STATION, RADIO, A14

TECHNICAL HANDBOOK - MISCELLANEOUS INSTRUCTION

SUB-TITLE: Replacement of VT1 in the r.f. amplifier

TELECOMMUNICATIONS  
F 169 Misc Instr No 2

Fig 1 - Stitching detail

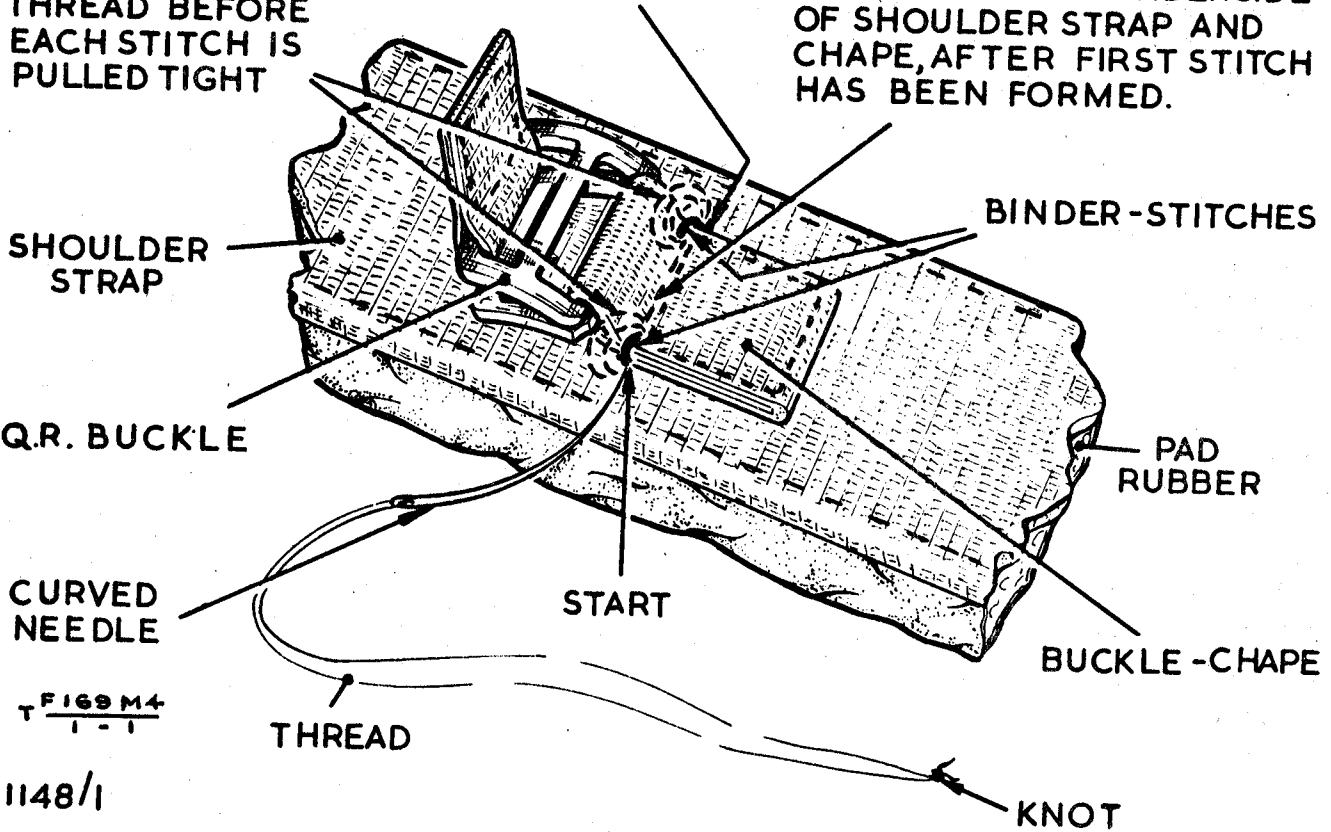
Reports have been received that the stitching securing the buckle-chapes to the shoulder straps on the Bag, carrying webbing is insecure. Investigation showed that the stitching on a number of bags, had not been finished off correctly. This instruction details the action to be taken when the stitching retaining the buckle-chapes to the shoulder straps is found to be insecure.

The binder stitch is made by hand, using a needle and double thickness thread, the needle being either a curved upholsterer's or saddler's type used for double-hand stitching. Use thread 18/3 cord linen, proofed and dyed to match existing sewing. The needle is threaded double-thickness and knotted at the end, then inserted into the shoulder-strap close to the buckle-chape, piercing the shoulder-strap and emerging through the underside of the shoulder-strap and buckle-chape through the stitch hole approximately 1/8 in. from the edge of the buckle-chape. Form the binder stitch by over-stitching the edge of the buckle-chape to the shoulder strap twice, as shown, pulling the thread tightly each time. The needle and thread are then passed through the underside of the shoulder straps to emerge through the shoulder straps close to the edge of the buckle-chape and the binder stitch formed as previously, double knotting to secure. It is to be noted that separate binder stitches may be made by omitting the operation of passing the thread through the underside of the shoulder strap, providing the stitches are tightly secured.
